Form 3160-5 (June 2019)

1. Type of Well	MULTIPLE	
Oil Well Gas Well Other	8. Well Name and No. MULTIPLE	
2. Name of Operator EOG RESOURCES INCORPORATED	9. API Well No. MULTIPLE	
3a. Address 1111 BAGBY SKY LOBBY 2, HOUSTON, TX 77(713) 651-700		rea

Almost Eddy 30 Fed Com 500Hs

Revised Permit Information 03/23/2022:

Revised Wellbore

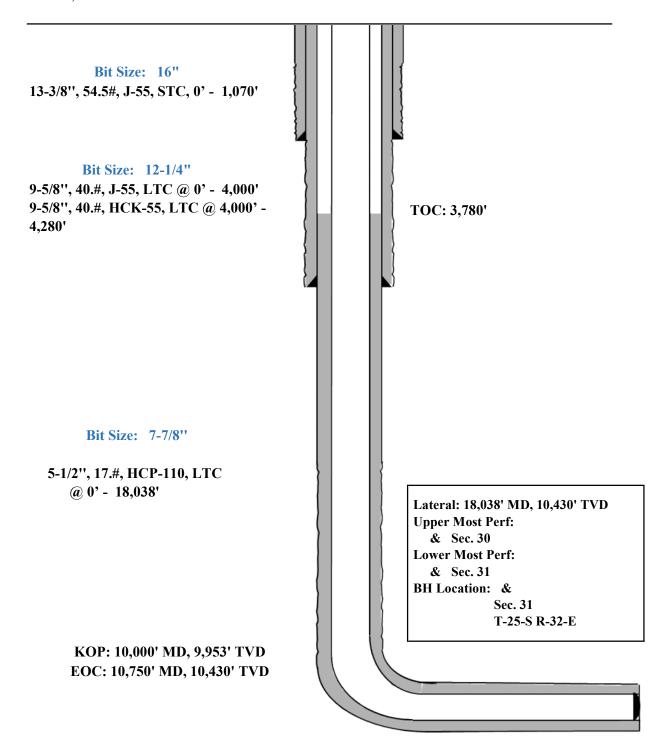
EOG respectfully requests to change the surface hole size from 17.5 to 16, and the production hole size from 8.75 by 8.5 to 7.875 (see attached casing design) for each well listed above.

Variance is requested to waive the centralizer requirements for the 9-5/8" casing in the 12-1/4" hole size. An expansion additive will be utilized, in the cement slurry, for the entire length of the 12-1/4" hole interval to maximize cement bond and zonal isolation.

Variance is also requested to waive any centralizer requirements for the 5-1/2" casing in the 7-7/8" hole size. An expansion additive will be utilized, in the cement slurry, for the entire length of the 7-7/8" hole interval to maximize cement bond and zonal isolation.
